# Authorized Field Change

AFC 17916

**Subject File:** Uptime Improvements

**Subject:** Update Instrument Cluster, Body Control Module (BCM), Light Control Module (LCM), Switch Pack Modules, Stalk Shifter Module, Aero Bumper Rock Screen and Inspection of Powertrain Harness

**Figure 6. Rock Screen Radar Frame with U-Clip Fastener (Bumper Interior)**

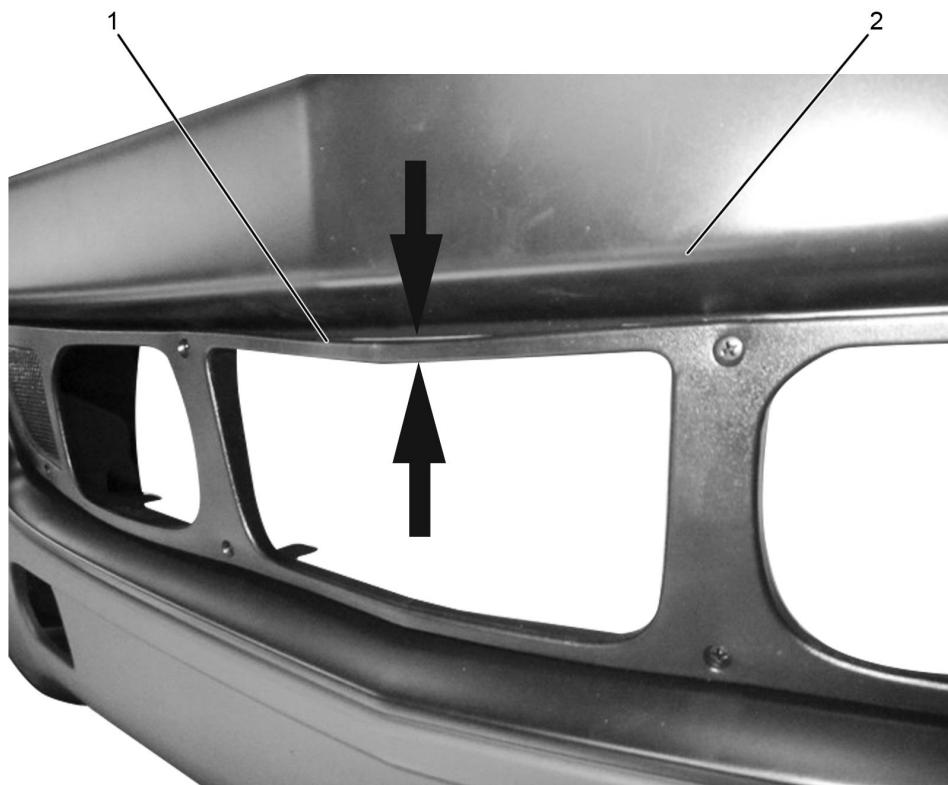
21. Align and install U-clip fastener (Figure 6, Item 2) with retaining tab face up to top center area of rock screen radar frame (Figure 6, Item 1), securing radar frame to inside edge of bumper applique (Figure 6, Item 3).

**Figure 7. U-Clip Fastener**

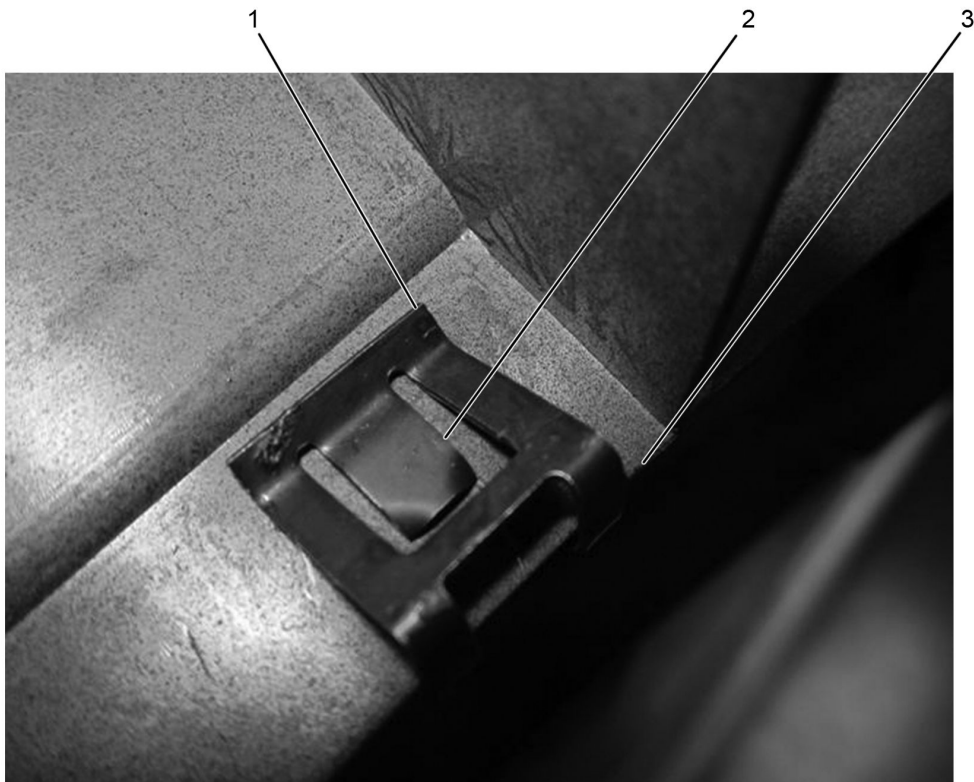
23. Visually inspect the inside bumper to ensure U-clip fastener (Figure 7, Item 1) is oriented with retaining tab (Figure 7, Item 2) face up onto bumper applique (Figure 7, Item 3) and seated fully.

**Figure 8. Left-Side Tie Strap Locations**

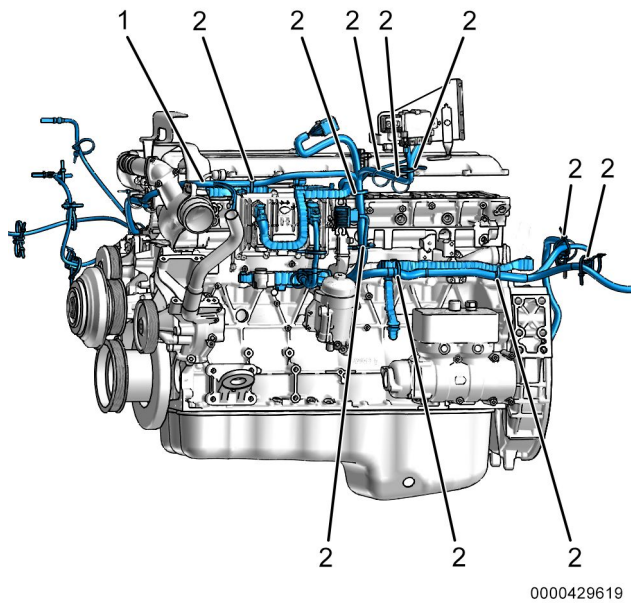
26. Locate tie strap clips; if tie straps are not installed, adjust harness (Figure 8, Item 1) routing and install tie straps (Figure 8, Item 2). If tie straps are installed, proceed to Step 27.

**Figure 9. Rear Tie Strap Locations**

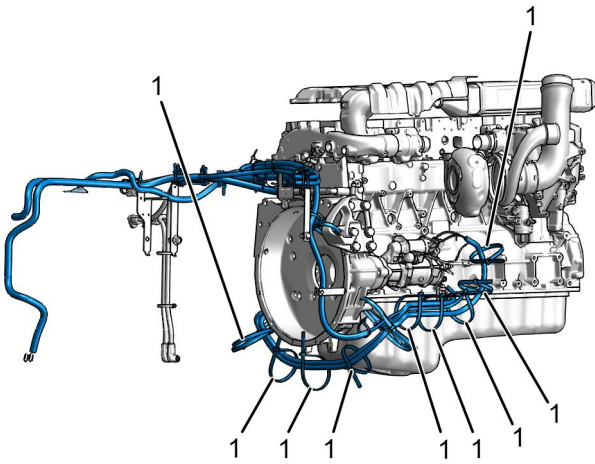
27. Locate tie strap clips (Figure 9, Item 1) on harness underneath turbocharger; if tie straps are not installed, adjust harness routing and install tie straps.

**Figure 10. LT Rear Bracket**

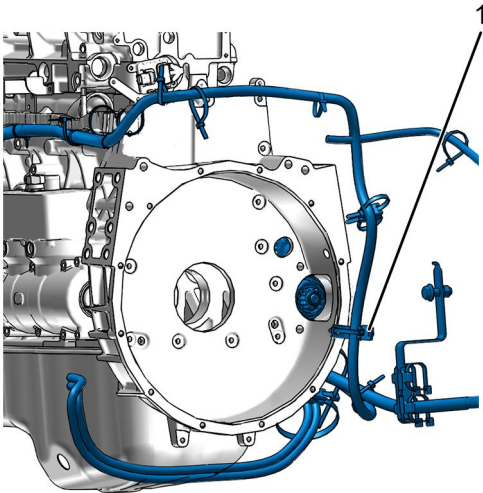
28. On LT™ Series vehicles, locate rear bracket (Figure 10, Item 1) and secure harness to bracket.

**Figure 11. RH Rear Bracket**

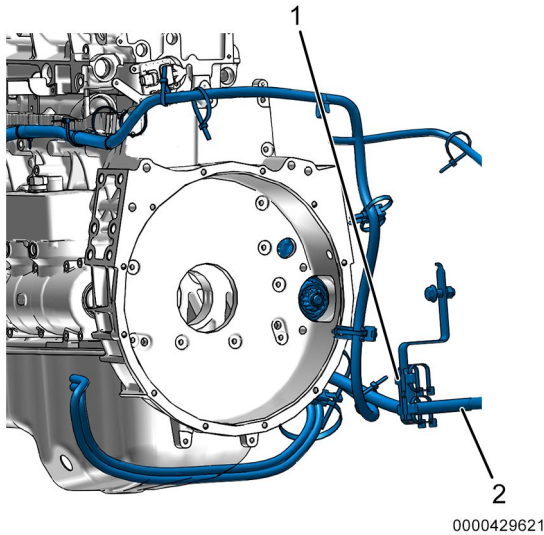
29. On RH™ Series vehicles or units with frame rail battery boxes, locate clip point (Figure 11, Item 1). If missing, secure powertrain harness to starter wire (Figure 11, Item 2).
